Oakton College District 535

Invitation to Bid # TLE-FY26-02

Addendum #1

ADJACENCIES RENOVATION – PHASE 2A – OSA AND WORKFORCE DEVELOPMENT

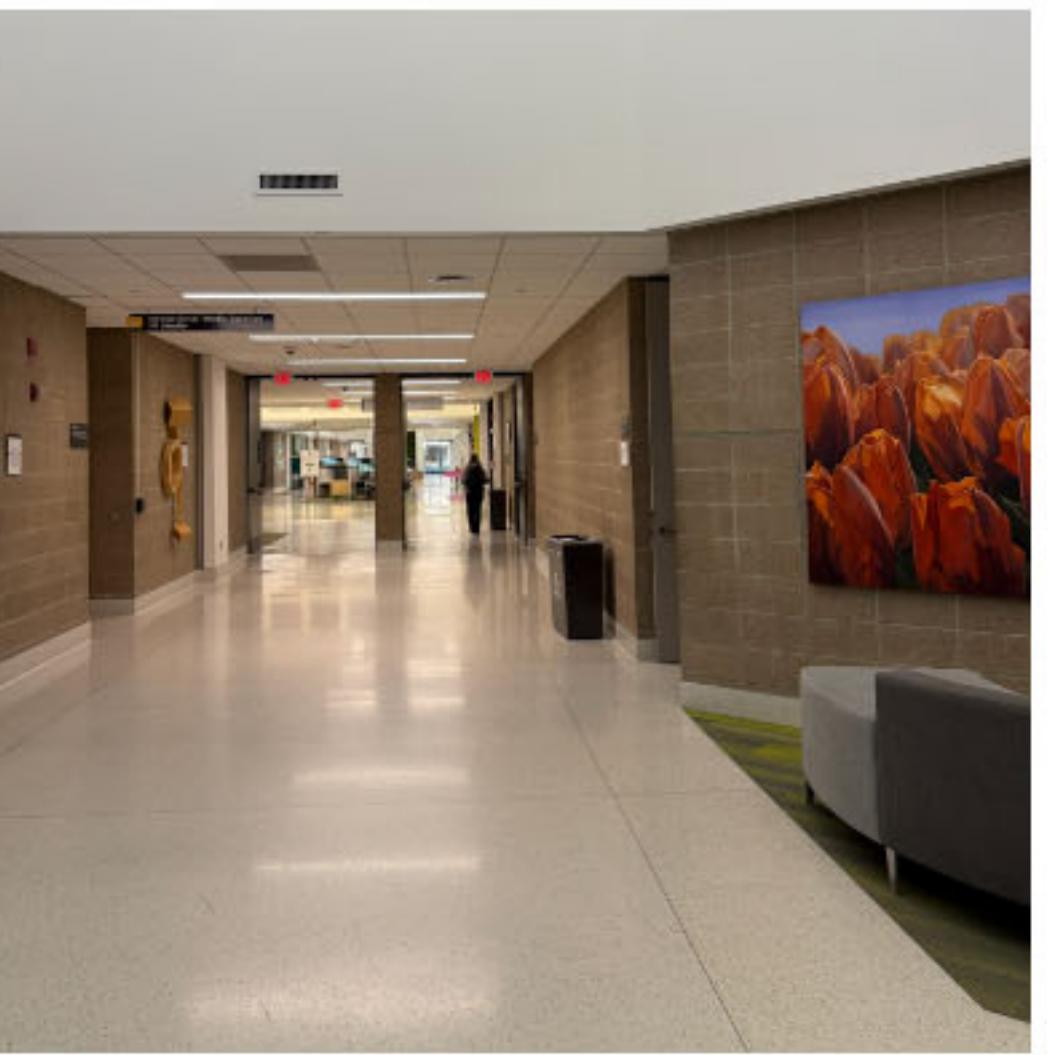
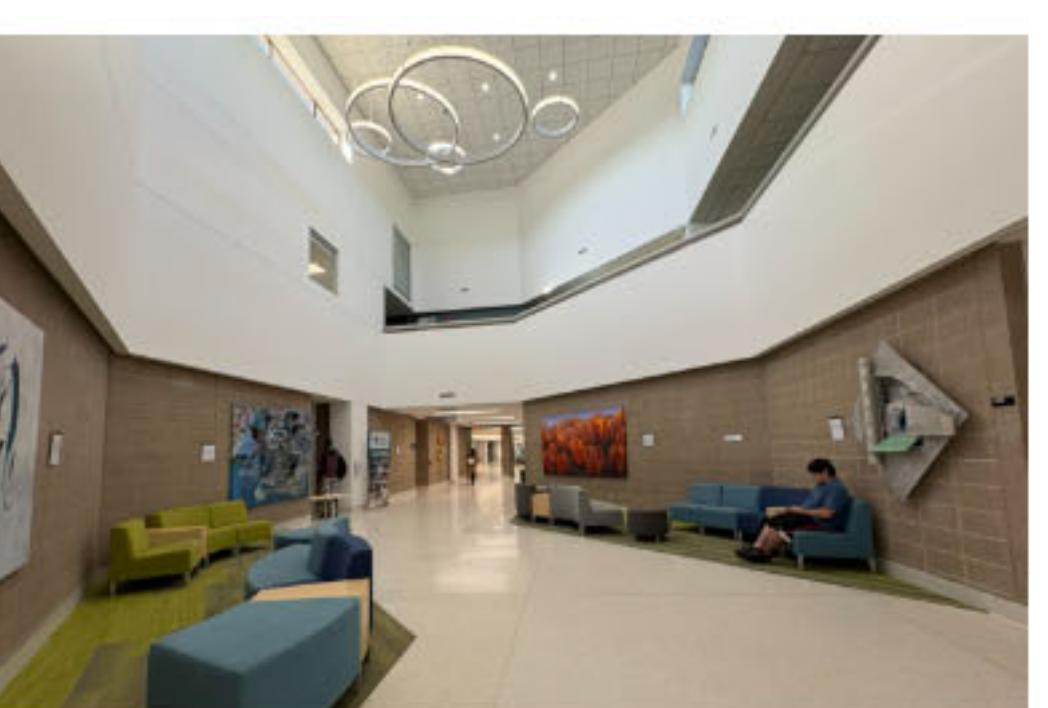
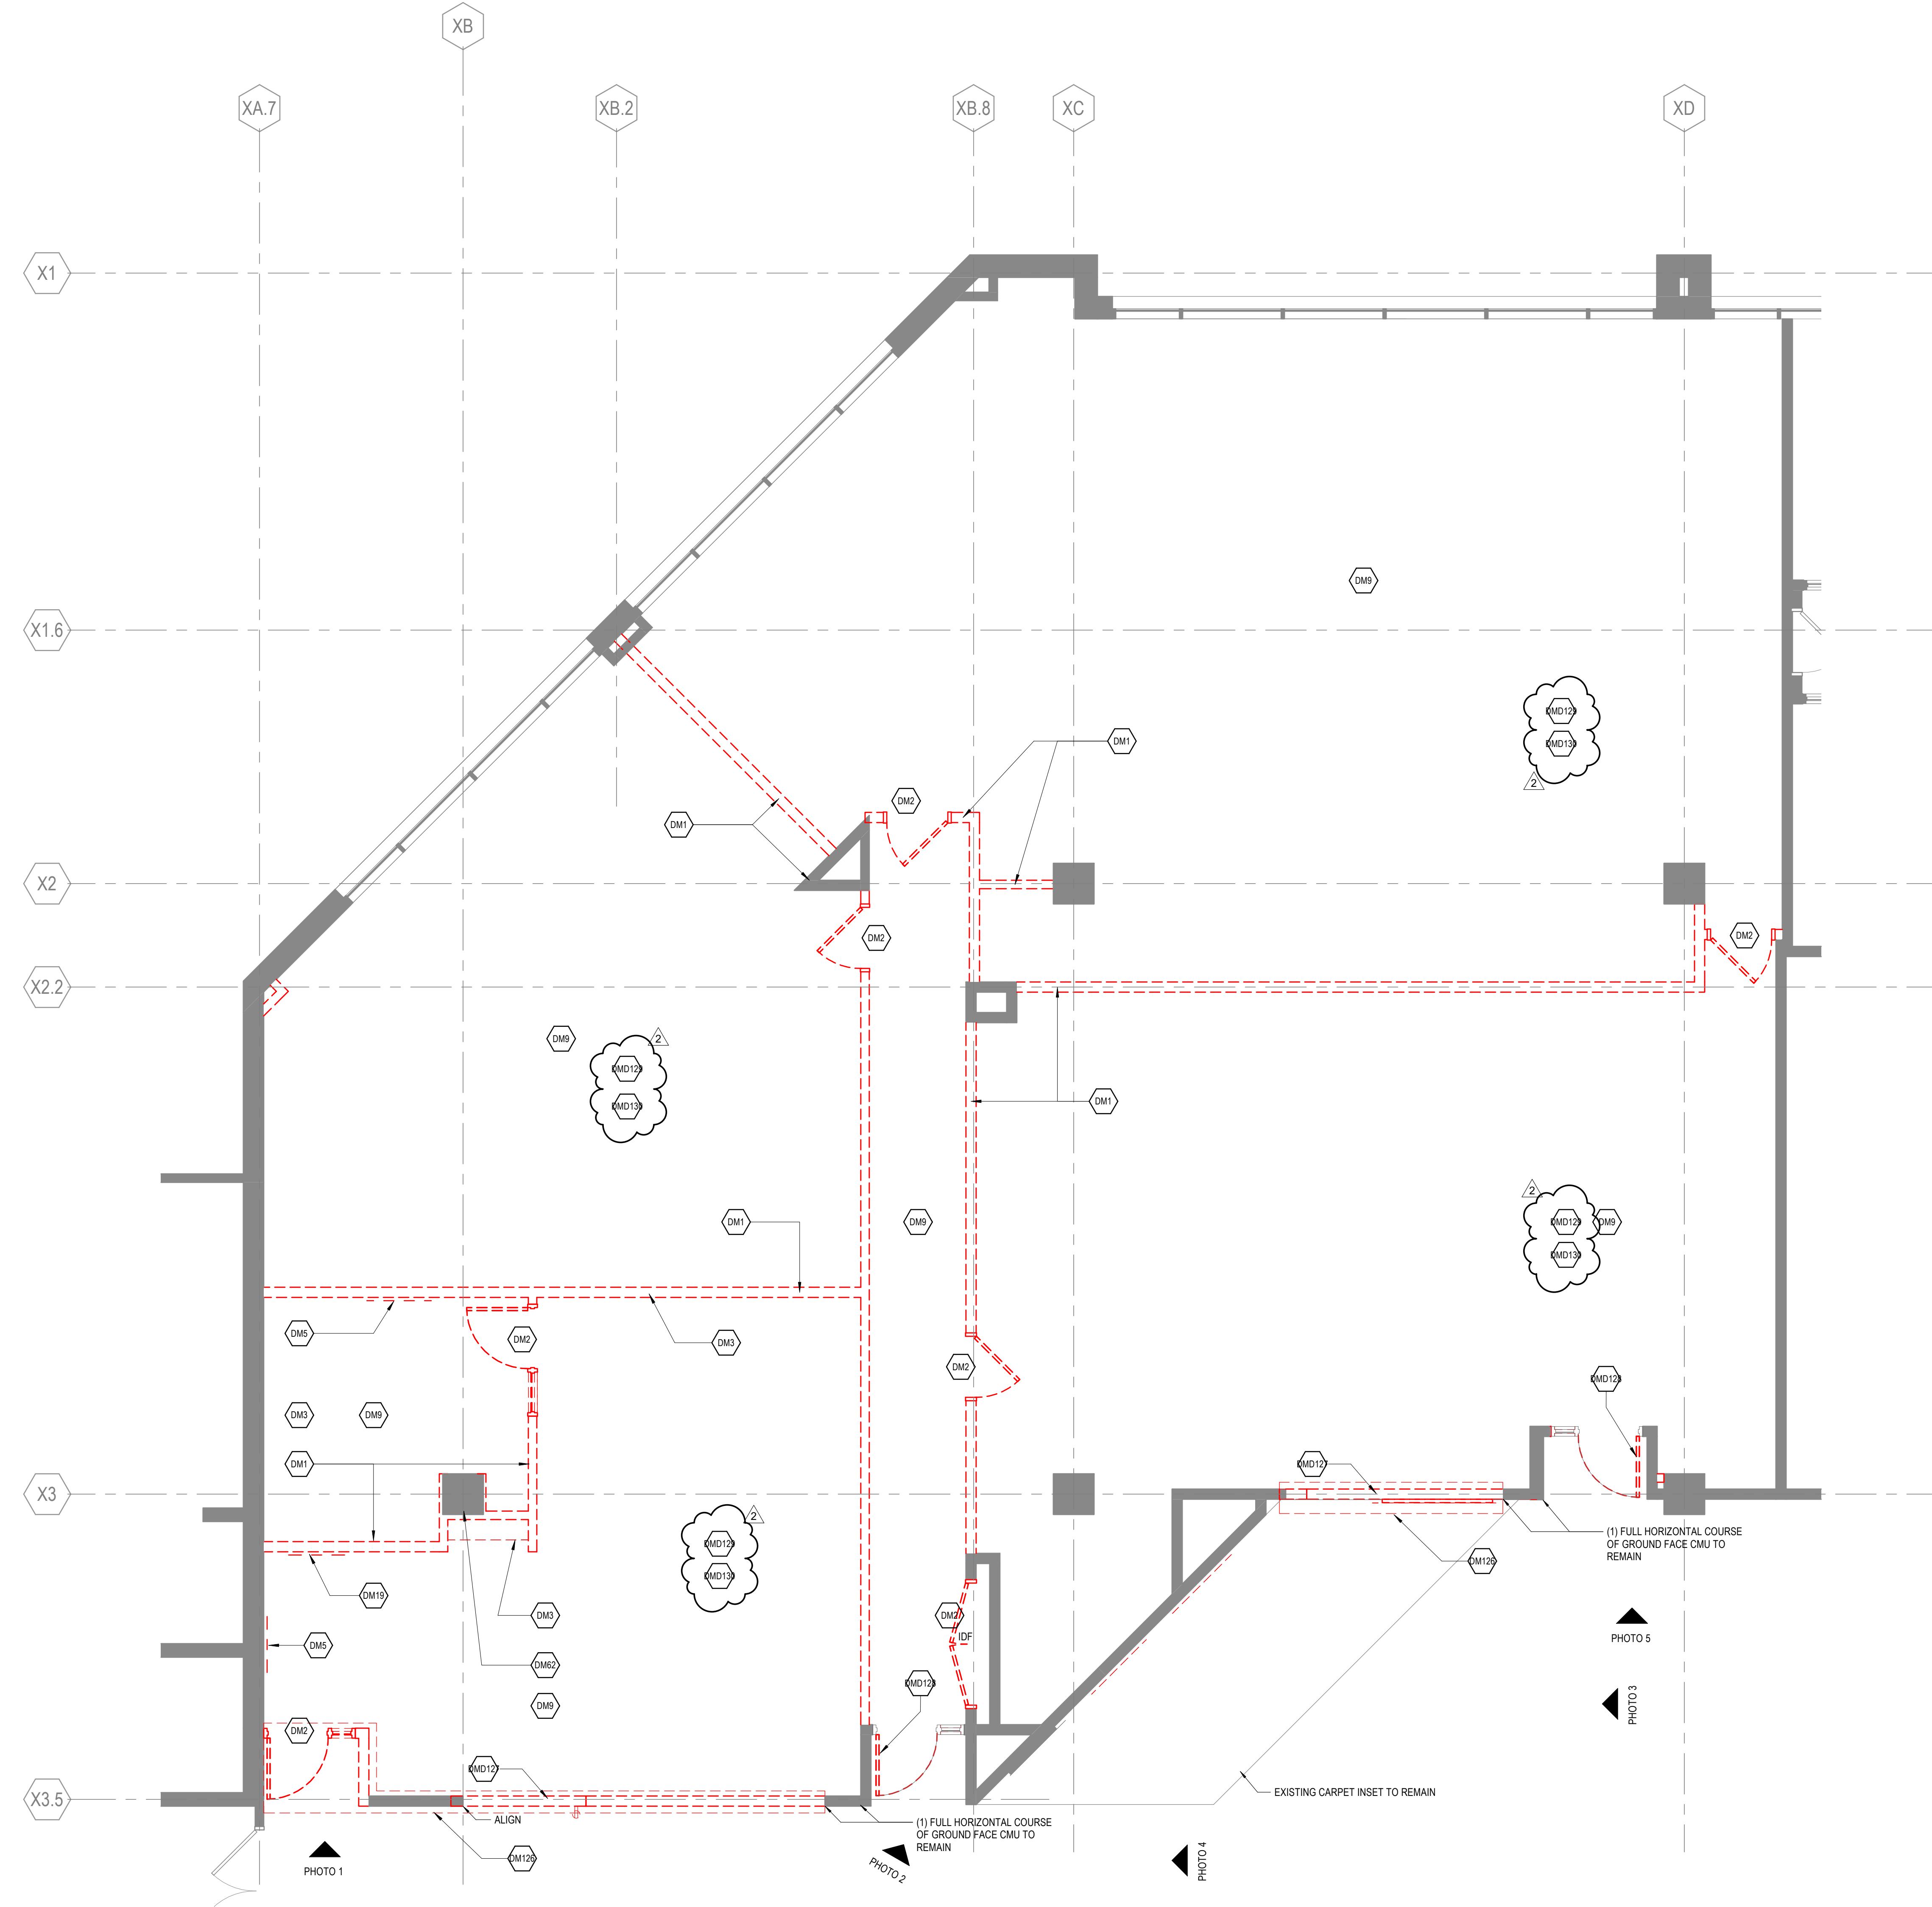
- A. Q: Could you please provide a logistic plan as well? Location of dumpster. Material unloading area? Building entrance location? May we use the elevator? If yes, its location?

A: Dumpster location will be negotiated with the College. The main utility elevator is available for contractor use, contractor will need to protect a path from the construction area to the elevator and provide elevator pads for the duration of the project. See the diagram below, the elevator is located in the blue rectangle, construction area in the red rectangle.

11.A04-02

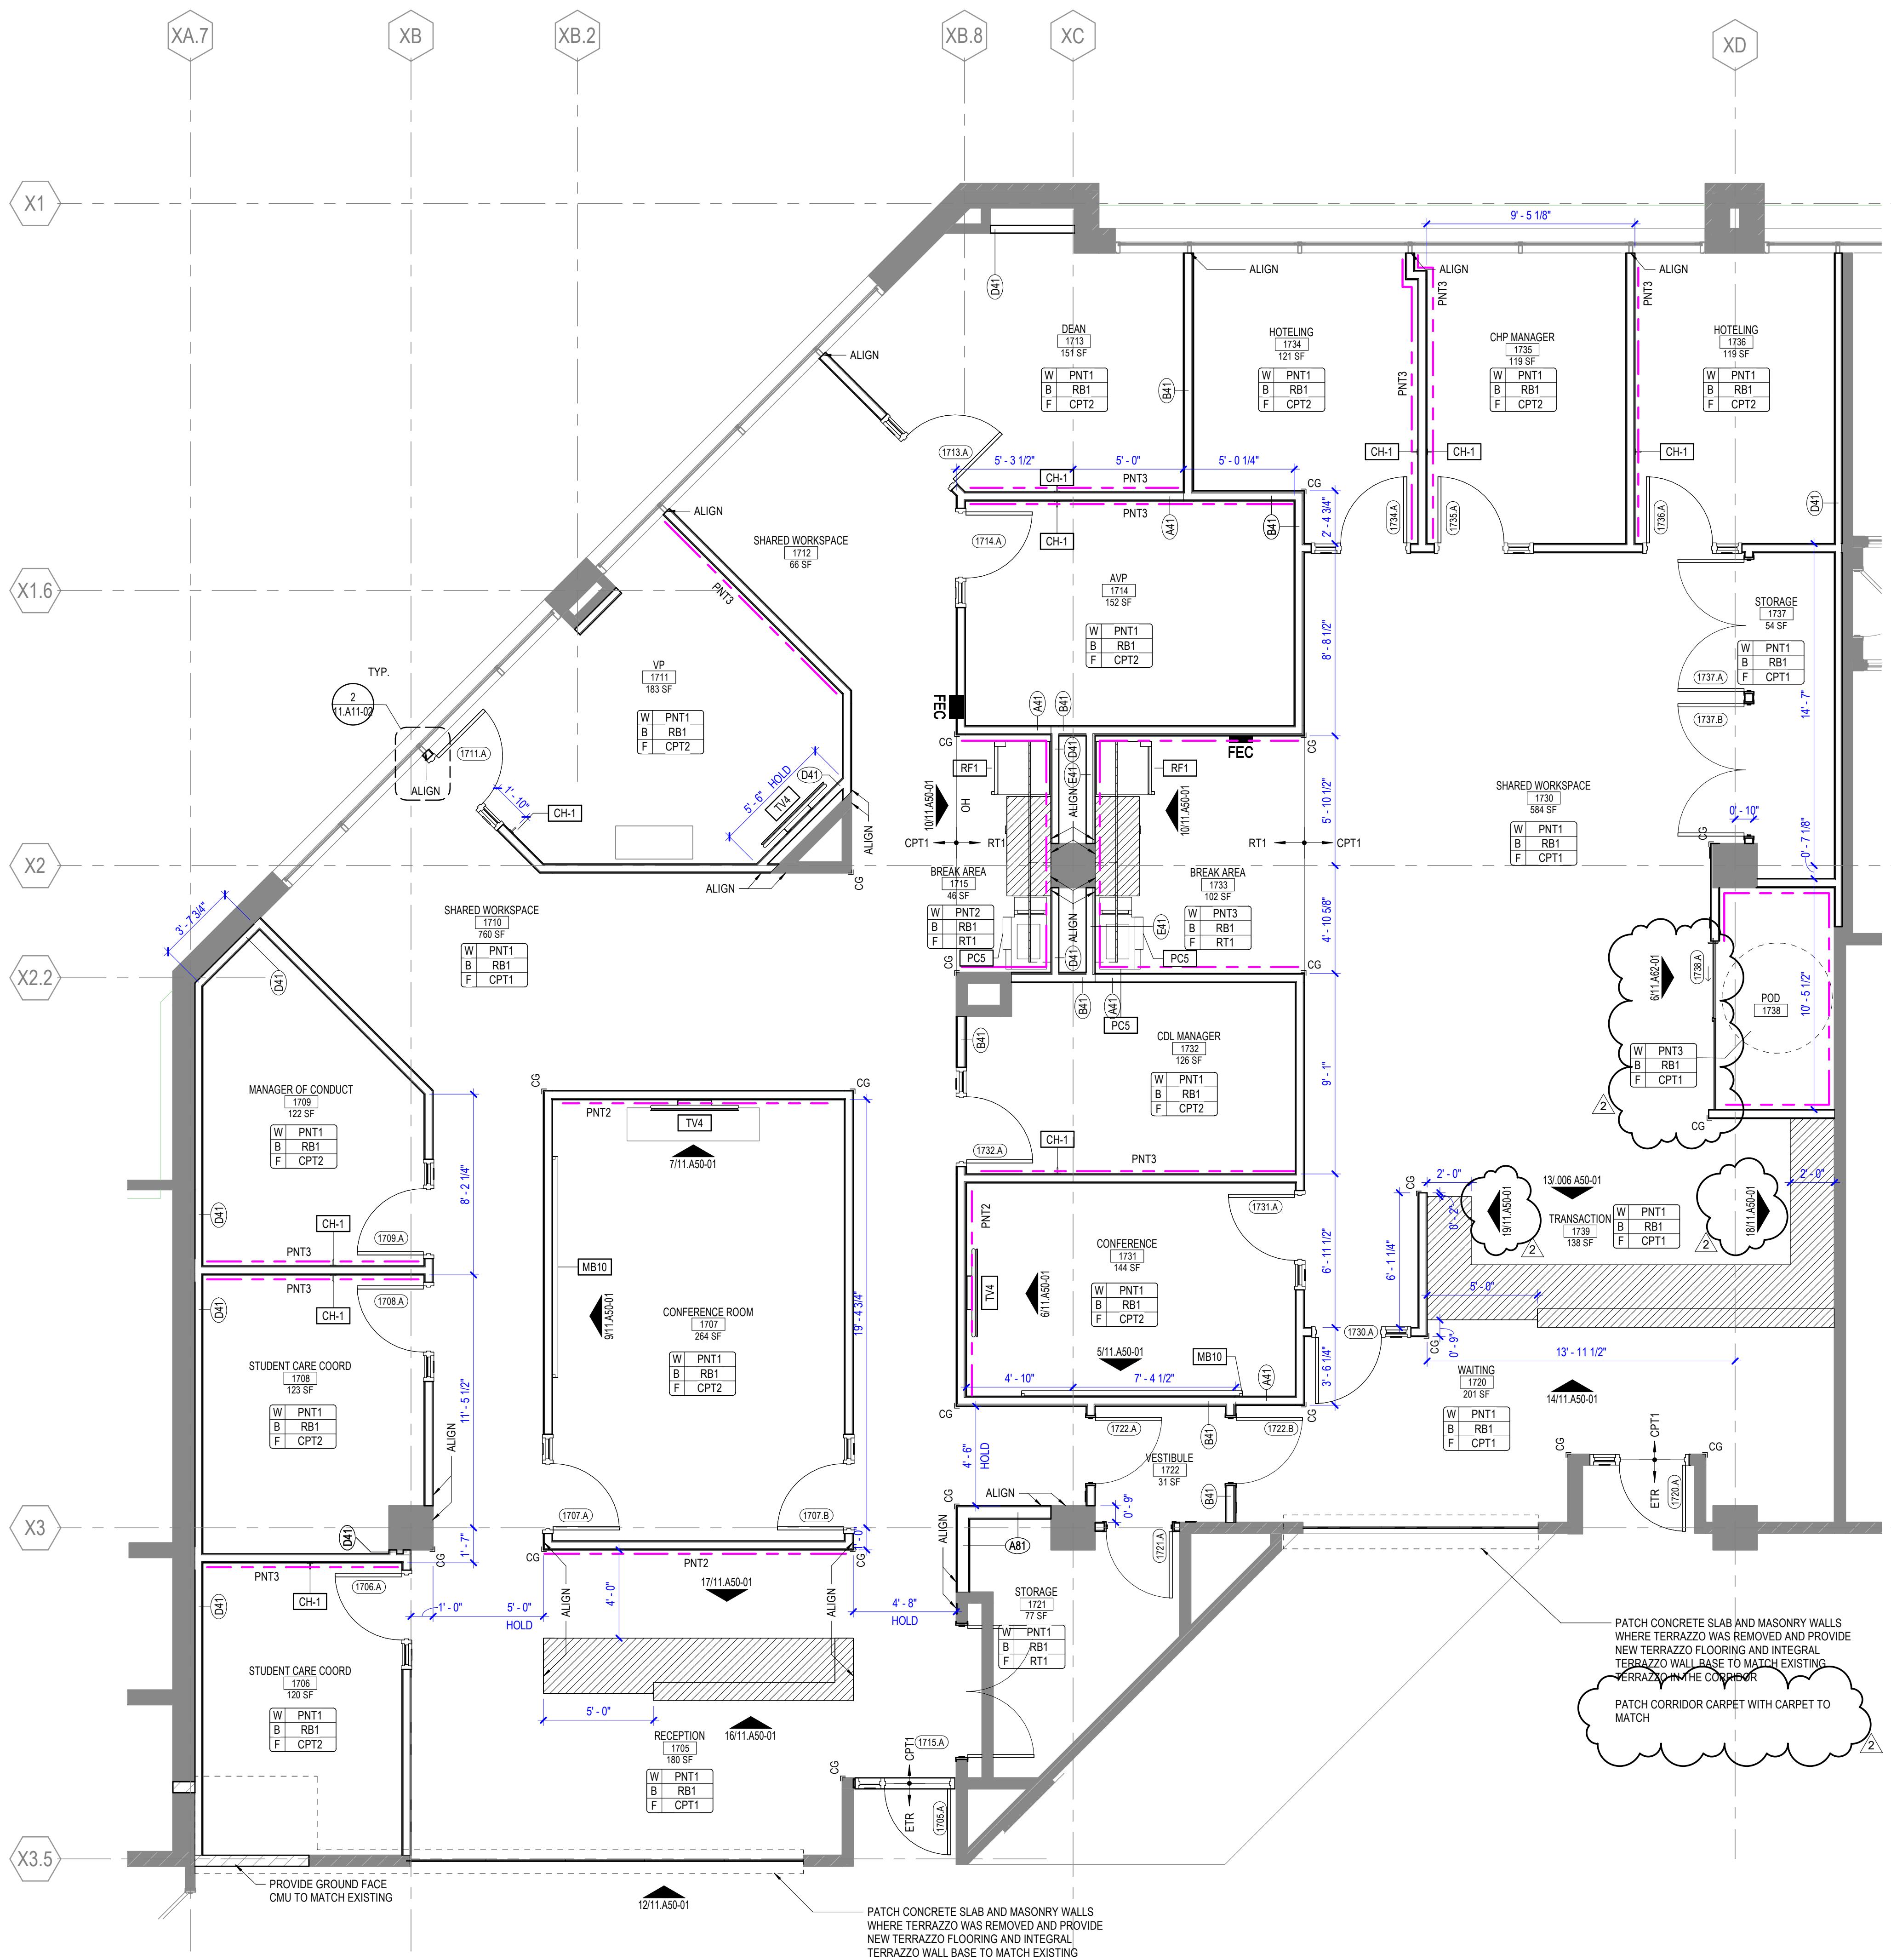
M. Q: CMU: Please clarify and provide more details on the CMU removal. Is it a 6" CMU wall? Does it go all the way to the deck or just above ceiling? Is it load bearing and will require shoring? Please see attached and advise if this is a chase wall?
A: Shoring requirements are solely the responsibility of the contractor. From historical work in this area of the building, demising walls are traditionally gypsum board or plaster board over light gauge framing. Some areas have had concealed CMU under framing, especially at chase and utility walls/rooms. Corridor walls have traditionally been CMU to the underside of deck above. The building superstructure has been traditionally steel. The contractor should confirm existing conditions prior to demolition to confirm conditions are consistent with other areas of the building.
